**Overview:** Production error; immobilizer wire (orange/black) in pin position #4 instead of pin position #5. Although an effort to correct the issue was made, some quantity of harnesses did get shipped before the issue was spotted. We are advising to inspect the harness BLADE connector before attempting to install the harness and program the module.

**Overview:** The FTI-STP1 harness may require modification for use in **automatic transmission (AT)** applications, some of the product was able to be modified before release, but a small quantity was released before being able to be modified internally.

# FTI-STP1: Vehicle Coverage and Preparation Notes

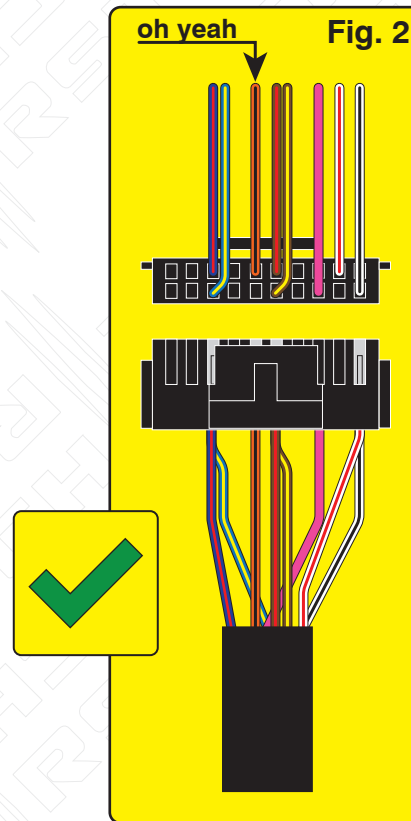
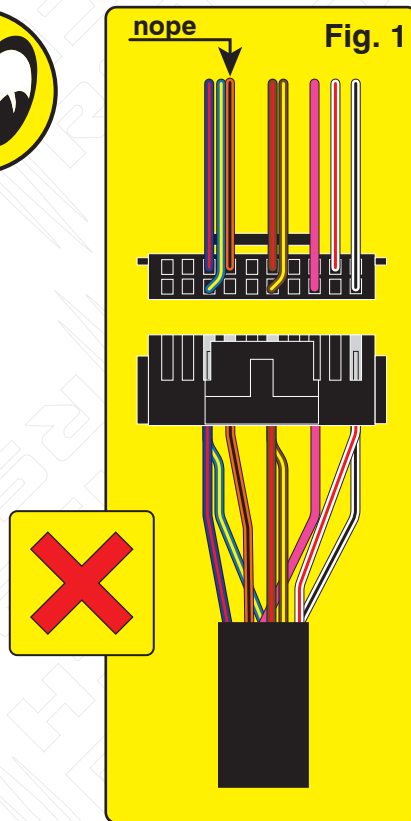
**Issue:** Module fails to program to vehicle, will not allow the vehicle to be remote started.

**Correction:** Step 1.) Locate the orange/black wire and confirm whether it is positioned as illustrated in Fig. 1 or Fig. 2. If the wire is as illustrated in Fig.1, proceed with Step 2 through 5 and complete the repair procedure outlined, if the wire is as illustrated in Fig. 2, correction is not necessary, proceed with harness installation and module programming.

**Step 2.)** Using a pick, lightly depress the catch that secures the terminal in the housing then remove the wire and terminal from the housing.

**Step 3.)** Using a fine tip razor or utility knife, insert the blade beneath the terminal catch and raise it slightly, so that it can be reused to secure the terminal when reinserted into the BLADE connector housing.

**Step 4.)** Refer to Fig. 2 for correct position of the orange/black wire (next to brown/red) then reinsert the terminal, pressing lightly until the catch 'snaps' into place, securing the terminal in the connector housing.

**Step 5.)** The repair is complete, proceed with installation and programming.

**MODIFICATION REQUIRED FOR AUTOMATIC TRANSMISSION APPLICATIONS ONLY**

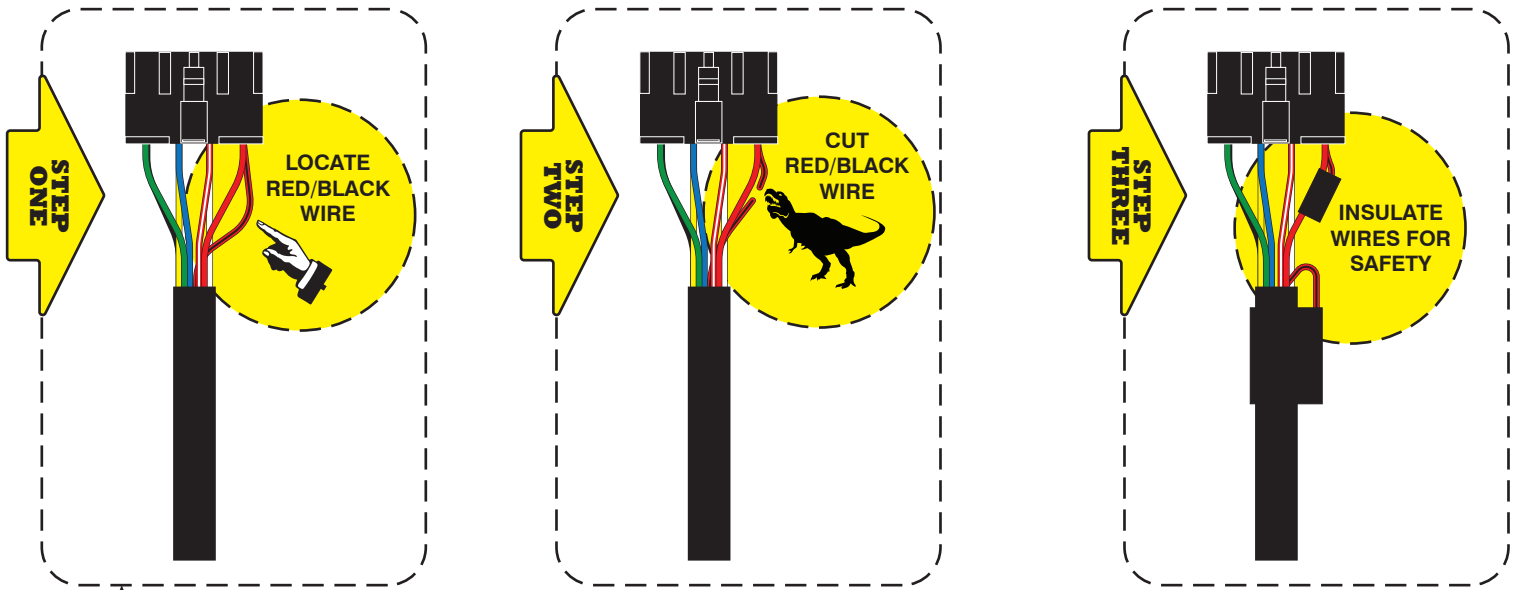
**Issue:** The FTI-STP1 T-harness has been designed to be compatible with AT (automatic transmission) & MT (manual transmission) applications, but due to a production oversight, the selection mechanism was defaulted to MT mode.

Using a harness configured for an MT application, in an AT equipped vehicle, could result in vehicle module damage, it is advised that the harness be returned to AT mode before installation in vehicles equipped with an automatic transmission.

**Correction:** Locate the **red/black (+ Clutch)** wire provided in the CN1 connector of the main harness assembly. Cut the **red/black** wire, either flush to the CN1 connector, or leaving enough wire exposed so that you can insulate and secure the ends of the wire that remain after cutting. Insulate each of the remaining ends of the **red/black** wire and secure to prevent any possibility of a short circuit.

If the red/black wire already been disconnected, no further modification is required for AT equipped vehicles.
